APPLICATION NO.	FILING DATE	FIRST NAMED INVENTOR	ATTORNEY DOCKET NO.	CONFIRMATION NO.
10/751,337	01/02/2004	Hans-Gerhard Kortmann	0275M-000845	7611
27572	7590	04/15/2005	EXAMINER	
HARNESS, DICKEY & PIERCE, P.L.C. P.O. BOX 828 BLOOMFIELD HILLS, MI 48303			SHARP, JEFFREY ANDREW	
		ART UNIT		PAPER NUMBER
				3677

Office Action Summary	Application No.	Applicant(s)
	10/751,337	KORTMANN ET AL.
	Examiner Jeffrey Sharp	Art Unit 3677

DETAILED ACTION

REPLACEMENT SHEET(S)
Title: FASTENER, METHOD OF MAKING IT, AND ITS USE
Attorney Docket No.: 0275M-000845
Inventors: Kortmann, et al.
Christopher M. Brock - (248 641-1600) Harness, Dickey & Pierce, P.L.C.

Fig. 3

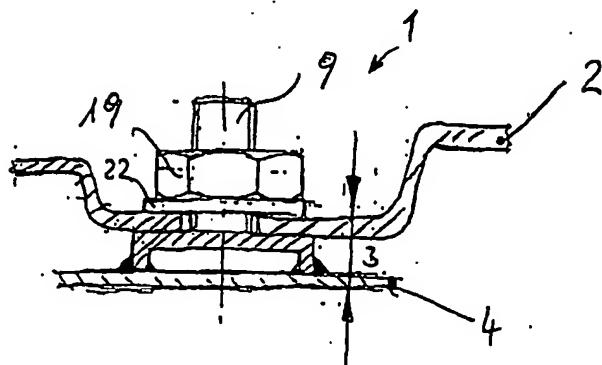
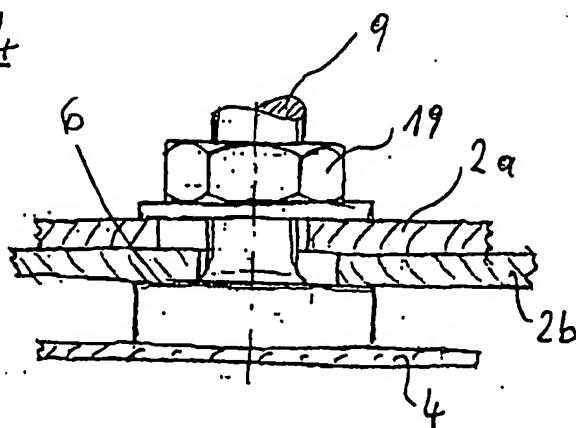
[2] The replacement drawing sheets submitted on 21 February 2005 have been approved and entered by the examiner. Accordingly, all objections to the drawings are withdrawn. Although Figures 3 and 4 appear unclean and hand-sketched, all features disclosed are legible.
